ENGINEERING EVALUATIONS AND STUDIES

FINAL REPORT FOR CONTRACT NAS 9-16067

VOLUME I, EXHIBIT A

NASA Lyndon B. Johnson Space Center
Houston, Texas 77058

Figure 1. Combined Antenna Pattern Showing the Interference Lobes During

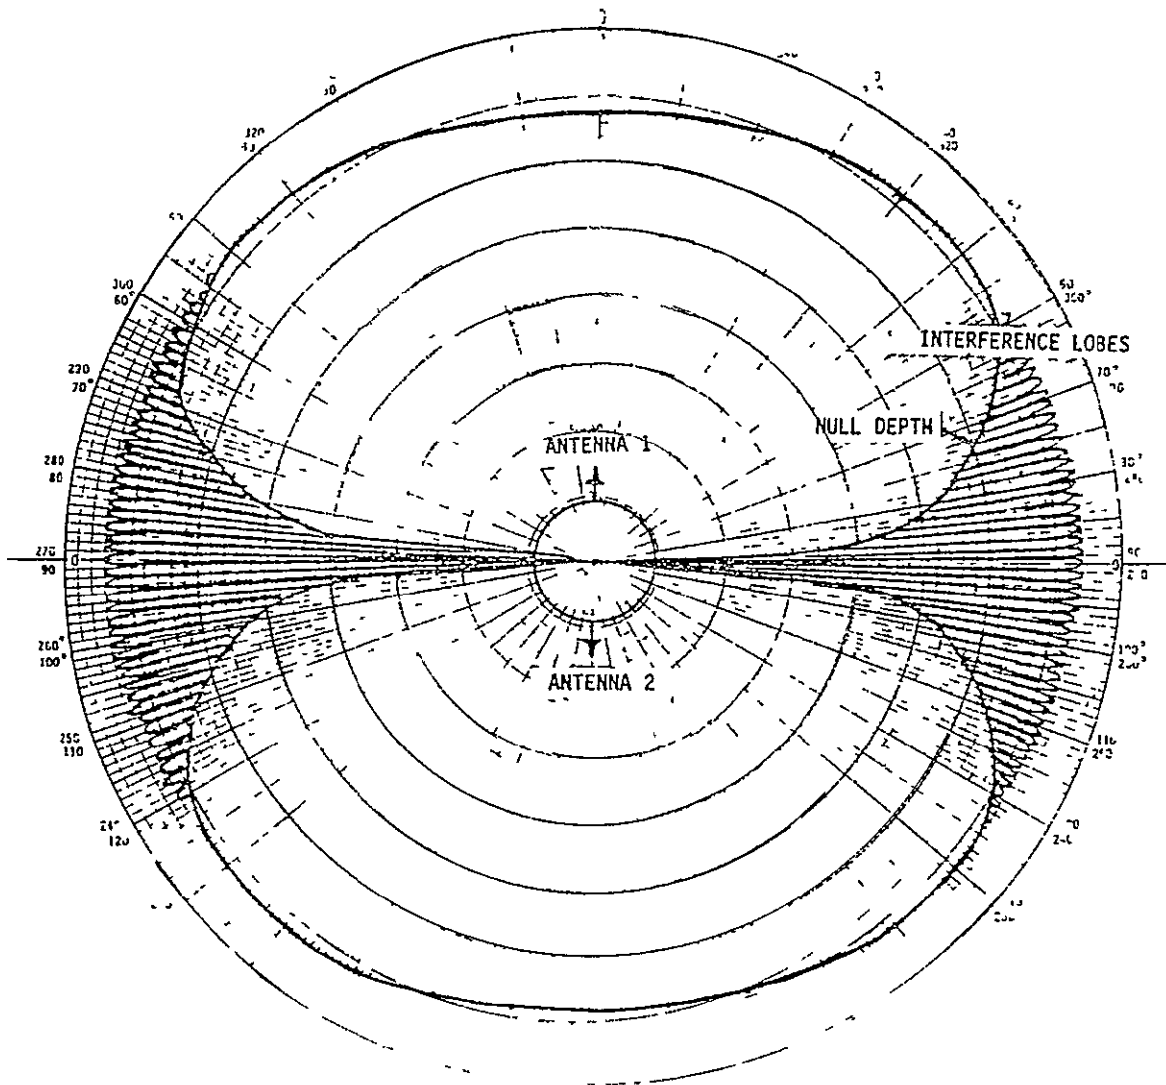
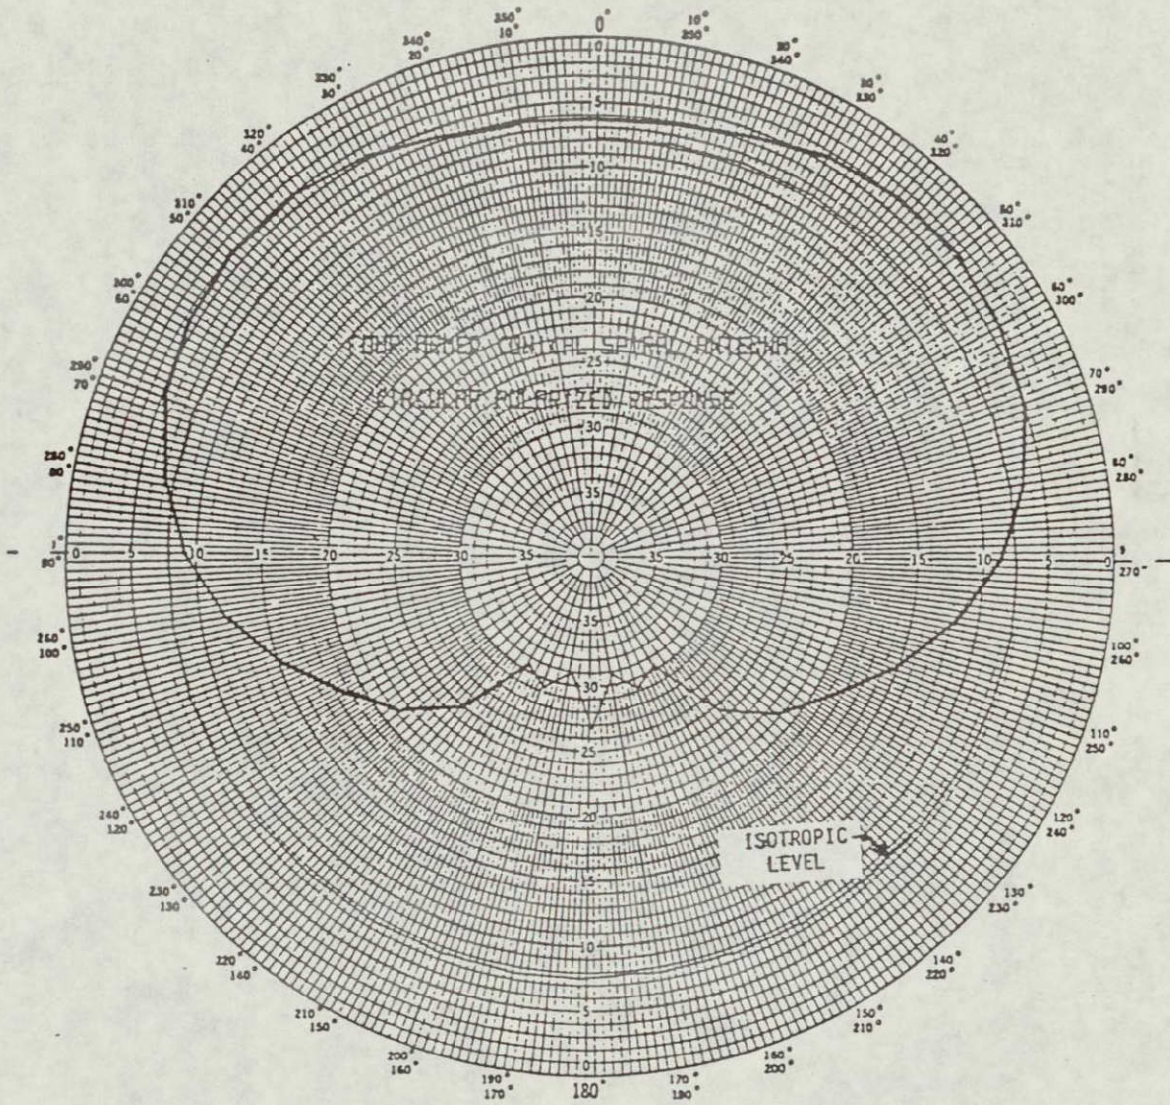
The first problem to be dealt with is the signal fade resulting from
the destructive interference from two radiating elements spaced widely apart
during the 5-ms "make-before-break" switching procedure Using the polar an-
tenna patterns in the General Dynamics memo, Figure 1 shows the interference
lobes for both antennas, Figure 2 shows a representative antenna pattern, and
Figure 3 shows an overlay of the two opposite antenna patterns plus the inter-
ference region superimposed, where constructive and destructive interference
occurs. Note that the signal during the switching period may either increase
or decrease in this region, depending on the position of the interference lobes
which are spaced 1.36° apart. The 5-ms switching transient constitutes only

In order to minimize this fading effect, it is proposed that the antennas be switched at a position where the null magnitude is the same as the radiation pattern of the opposite antenna such that the signal level will be at least constant (or, more probably, greater). There are four positions per revolution where this condition occurs, as indicated by the letters A, B, C and D in Figure 3. The imposition of this requirement maintains a minimum signal level of operation established by the worst-case interference null which, by definition, is the back lobe pattern of the opposite antenna that will be transmitting during the other half of the revolution. Obviously, it is desirable to have the highest gain possible in order to increase the minimum signal level, and this should be a consideration when specifying the desired antenna pattern, which can be adjusted appropriately.
